SUBJECT: Triangle Expressway Southeast Extension (Complete 540) from NC 55 Bypass in Apex to US 64/264 (I-87) in Knightdale, Wake and Johnston Counties; Federal Aid No. STP-0540(19), STP-0540(20), and STP-0540(21); WBS Nos. 37673.1.TA1, 35516.1.TA1, and 35517.1.TA1; STIP Project Nos. R-2721, R-2828, and R-2829

From: [Alsmeyer, Eric C CIV USARMY CESAW \(USA\)](#)
To: [Ridings, Rob](#); [Thomson, Nicole J](#)
Cc: [Abi Sheffey](#); [Riffey, Deanna](#); [Matthews, Monte K CIV USARMY CESAW \(USA\)](#)
Subject: [External] RE: Complete 540, R2828, Modification 12 Request; Permit Site 41; DA# SAW-2009-02240
Date: Friday, August 4, 2023 12:52:31 PM
Attachments: [image001.png](#)
[230803_Site 41 Mod drawings_R-2828_Complete540_Wake.pdf](#)

**North Carolina Division of Water Resources
Transportation Permitting Unit
In-Field Minor 401 Water Quality Certification Modification**

Project Name/ TIP Project No.: R-2828; NC Hwy 540 Date: August 4, 2023

PROJECT REFERENCE NO. <i>R-2828</i>		SHEET NO. <i>25</i>	
RW SHEET NO.			
ROADWAY DESIGN ENGINEER		HYDRAULICS ENGINEER

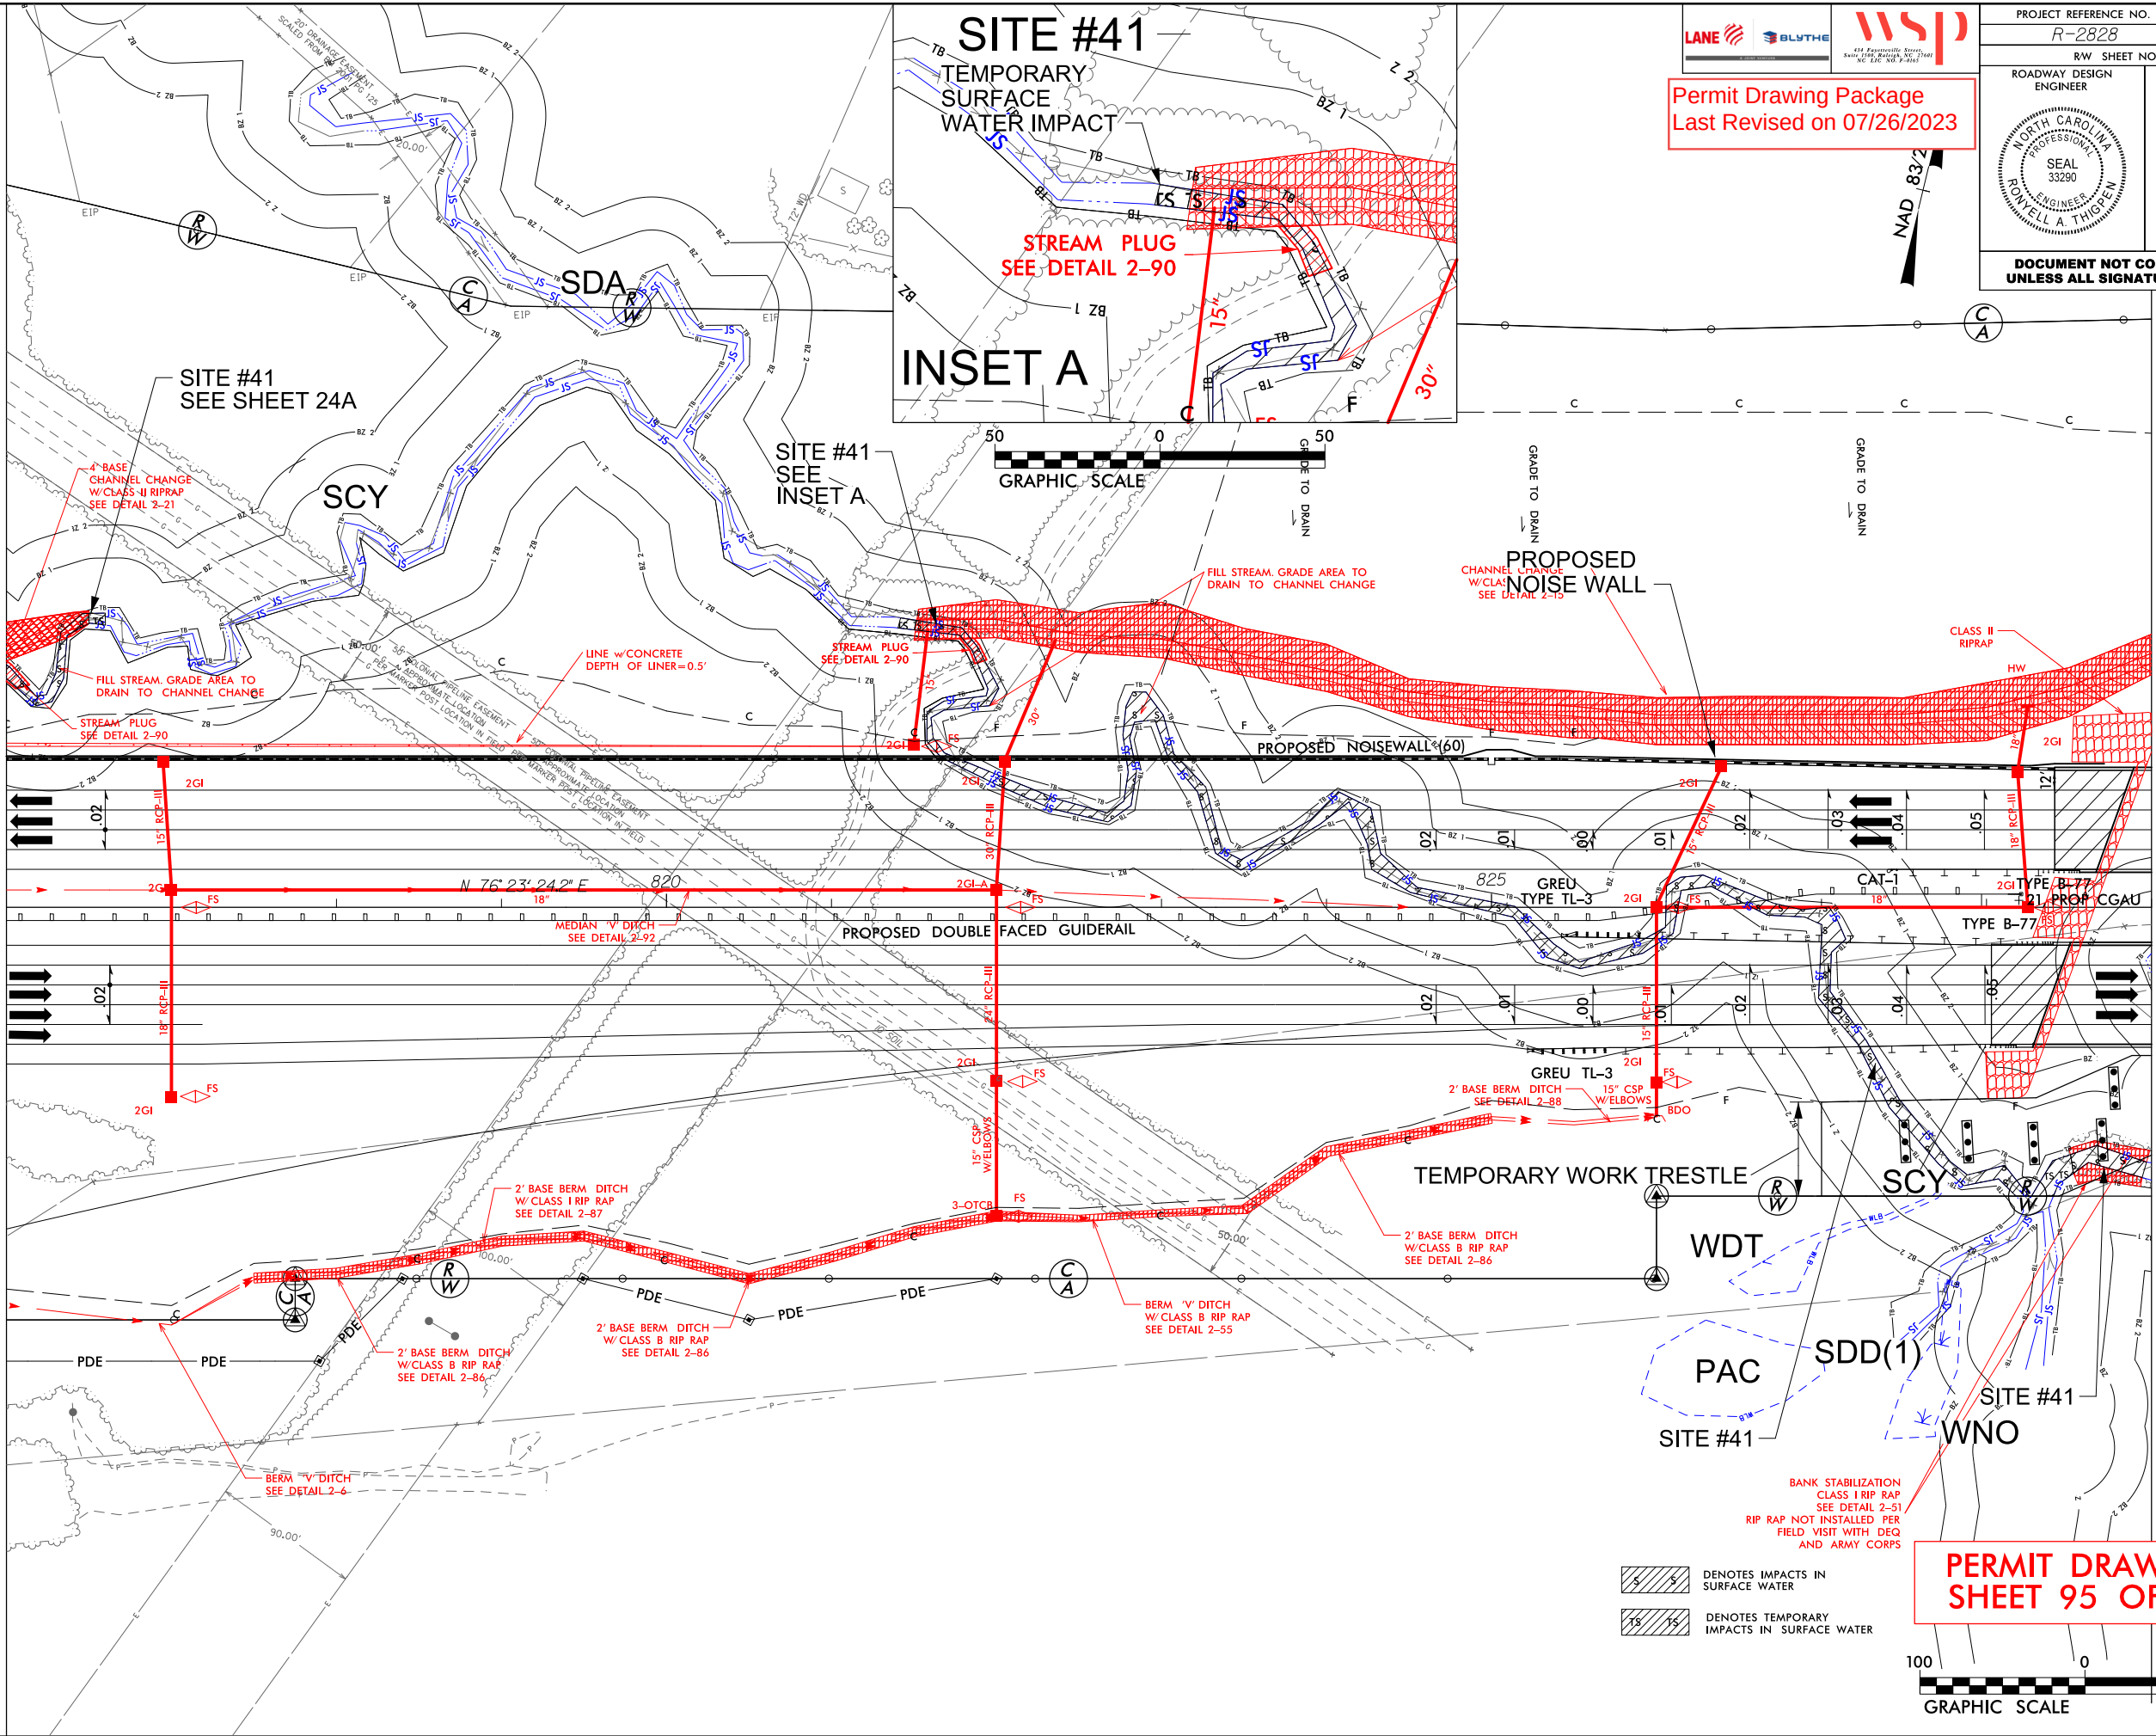
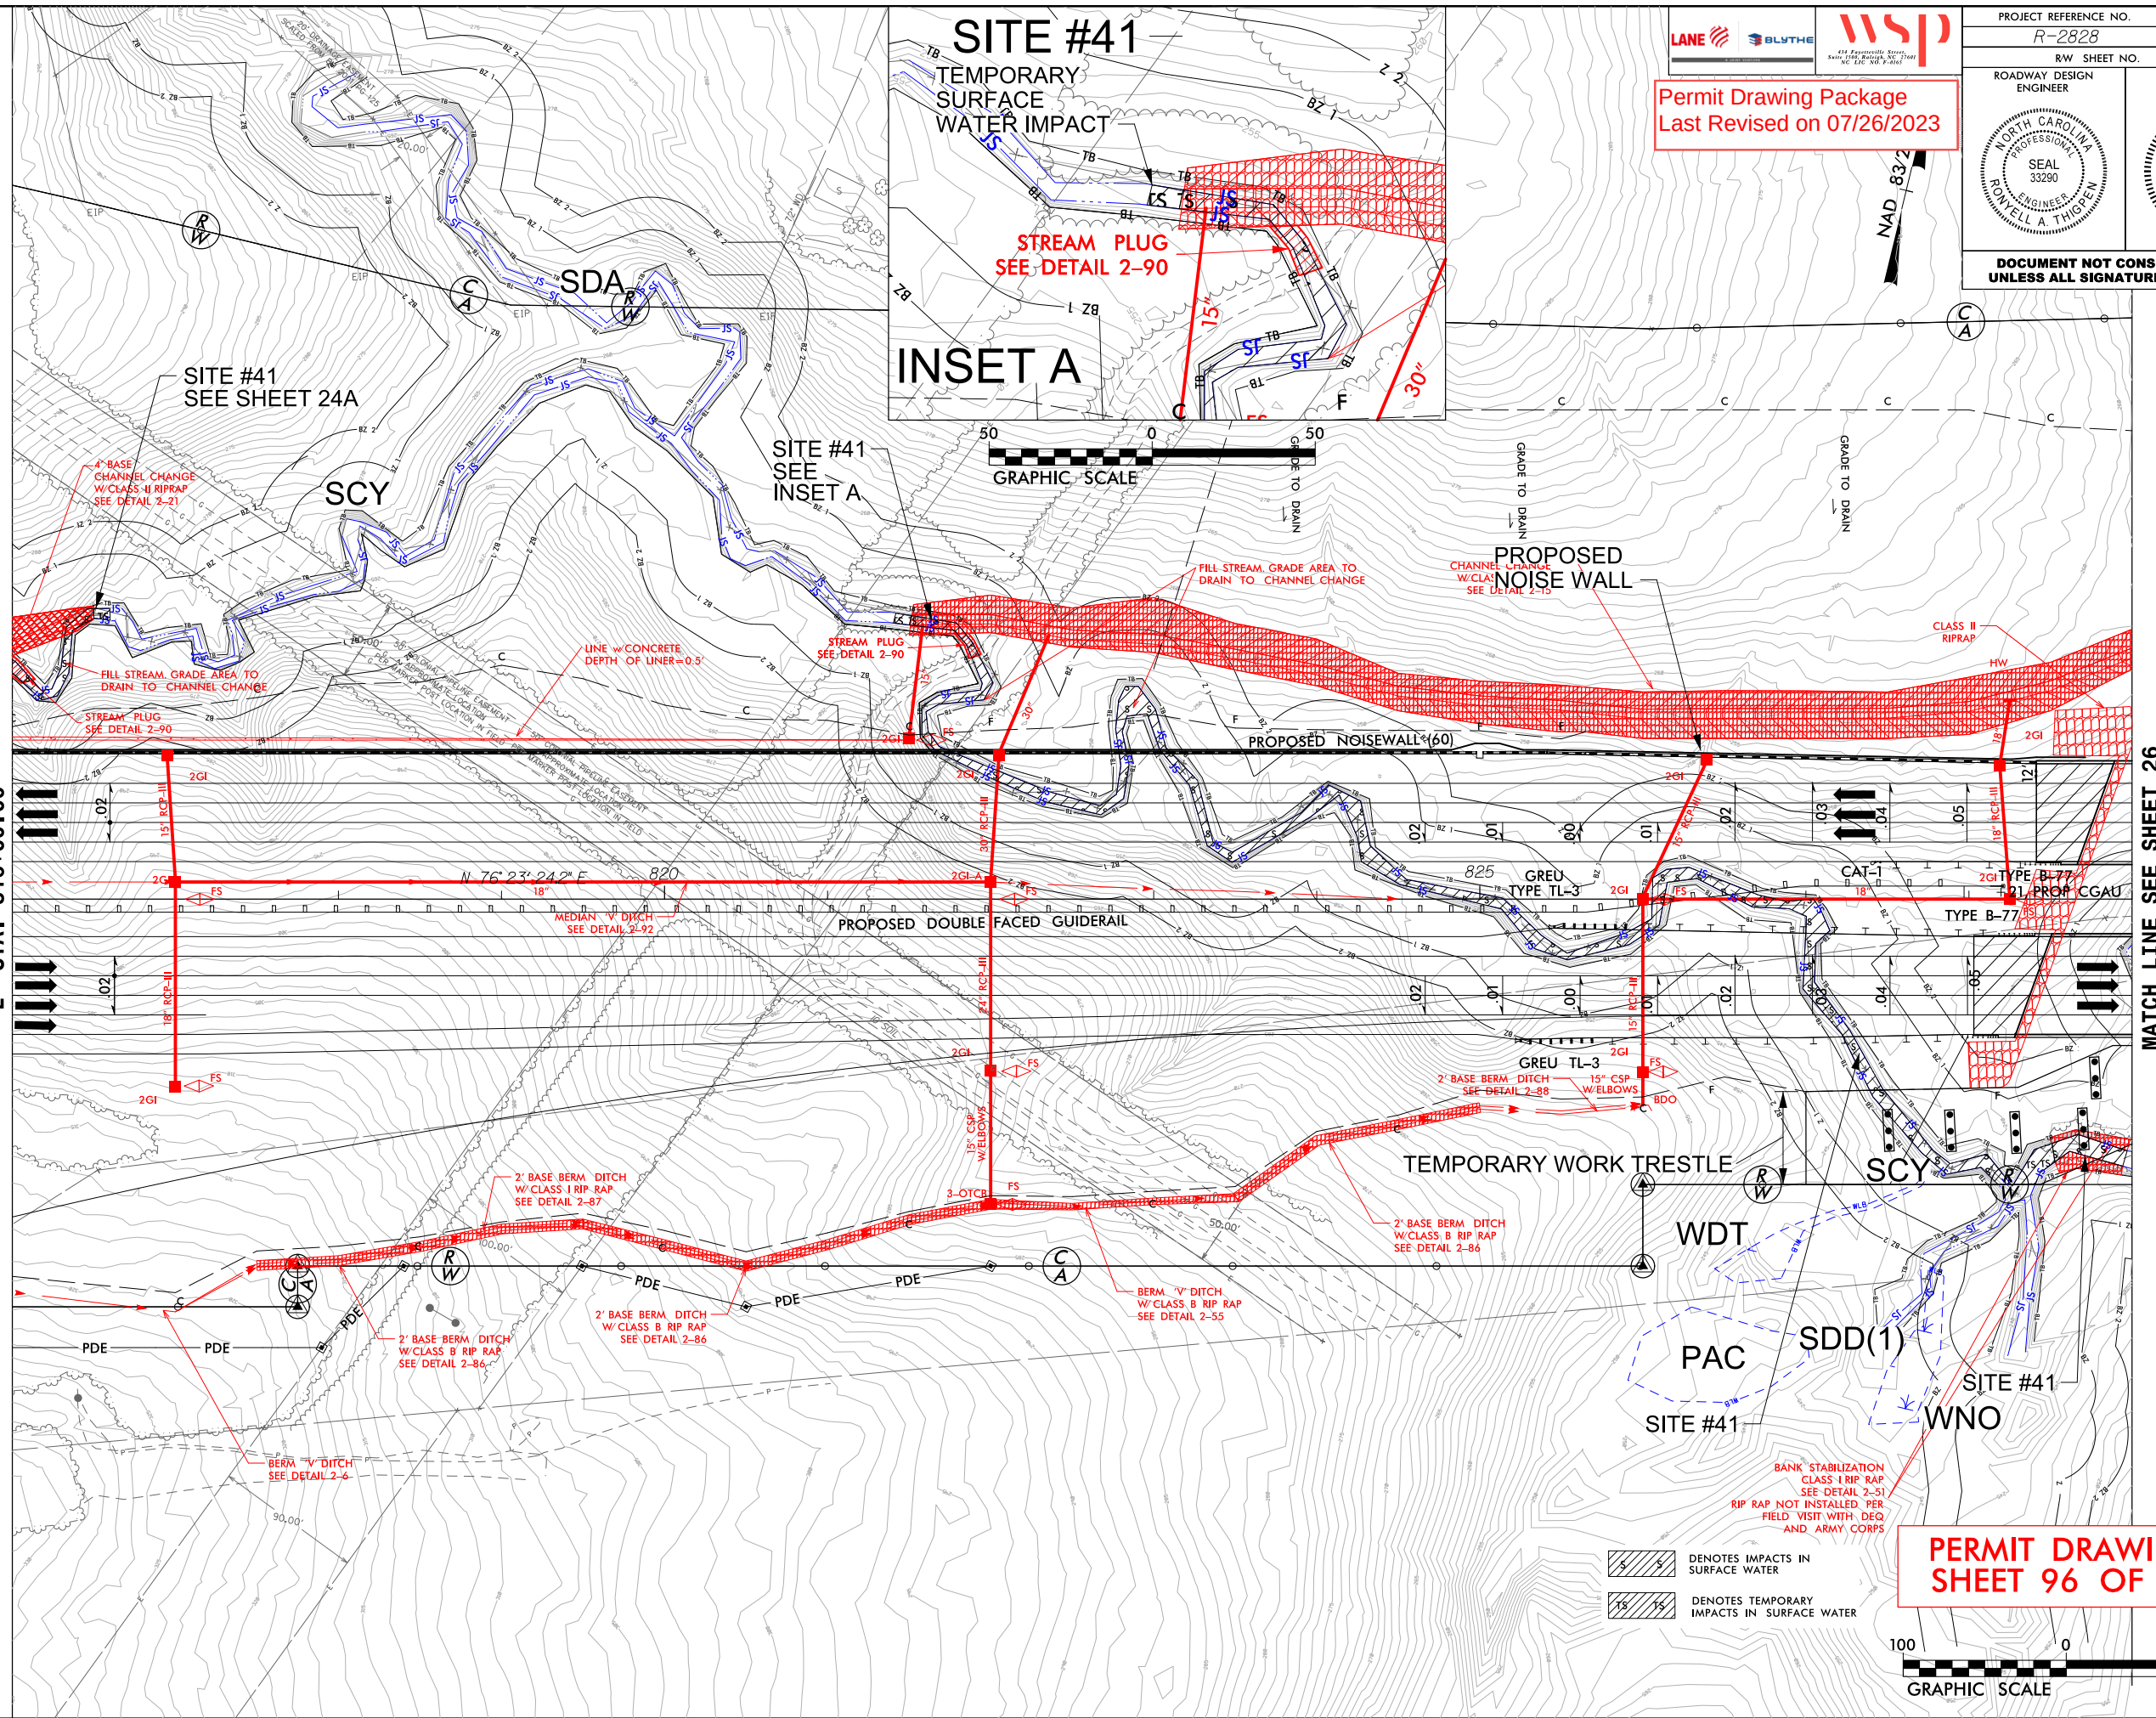
On August 3, 2023, the U.S. Army Corps of Engineers (Corps) received a request from NCDOT to modify the standard permit for the R-2828 project (Mod12), to adjust Impacts at Permit Site 41, Bridge Structure 9. The temporary work trestle bridge at Permit Site 41 was recently removed and some of the bank stabilization originally called for and permitted at this site was determined to not be needed. Another bank location at the site was originally permitted for only temporary impacts, but now requires permanent bank stabilization. There was significant scour at this bank location revealed after the temporary work structure has been removed, some of which was influenced by beaver activity in the area. Riprap for stabilization will not be placed in the thalweg of the channel.

- Limited area of bank stabilization:
 - Increase of 57 linear feet, 0.01 acre, of bank stabilization.
- Reduction of temporary stream impacts:
 - Decrease of 57 linear feet, 0.016 acre of temporary stream impacts

You were previously made aware of adjustments to Permit Site 41 at Bridge Structure 9. The temporary work trestle bridge was recently removed and per an earlier agency review, some of the bank stabilization originally called for and permitted at this Permit Site were ultimately determined to not be needed (concurred upon by both of you during the agency site walkthrough). Now there is a bank location originally permitted for temporary impacts that the JV wishes to convert to permanent bank stabilization. There was significant scour realized at this bank location now that the temporary work structure has been removed, some of which was influenced by beaver activity in the area. The attached permit drawings clearly identify the bank stabilization locations which were not installed and the new location where it is needed.

- Limited area of bank stabilization:
 - Increase of 0.01 acre of bank stabilization.
 - Increase of 57 linear feet of bank stabilization.
- Reduction of temporary stream impacts:
 - Decrease of 0.016 acre of temporary stream impacts
 - Decrease of 57 linear feet of temporary stream impacts

The Corps has completed the evaluation of your request and has determined that it is appropriate and reasonable, and that no public notice is required for this modification. Therefore, the permit is modified as requested and as shown on the attached drawings. No additional compensatory mitigation is required.
